## REVISION 002 TO A INVITATION TO TENDER

<b>Title - Sujet :</b> Tunnel Mountain Operations Shallow Utilities, Banff National Park	
<b>Solicitation No. - N° de l'invitation :</b> 5P421-21-0050/A	<b>Date :</b> January 28, 2022
<b>Amendment No. - N° de modification :</b> 002	
<b>Client Reference No. - N° de référence du client :</b>	
<b>GETS Reference No.   N° de référence de SEAG :</b> PW-21-00976647

## Amendment 002

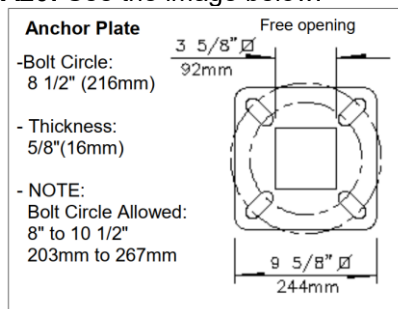
**Q18:** What is the water line drain pit? Can more detail be provided? Dimensions, depth, width, height? Pictures?

**A18:** The water line drain pit is a creosote wooden box which is to be removed as part of the scope. The wooden box is approximately 0.9m wide x 0.6m long x 0.75m deep, installed flush with the surface. Scope includes removing all wood, cutting and removing the HDPE waterline and associated valves, and backfilling with salvaged material from site. All demolition material is to be disposed of at suitable disposal facility.
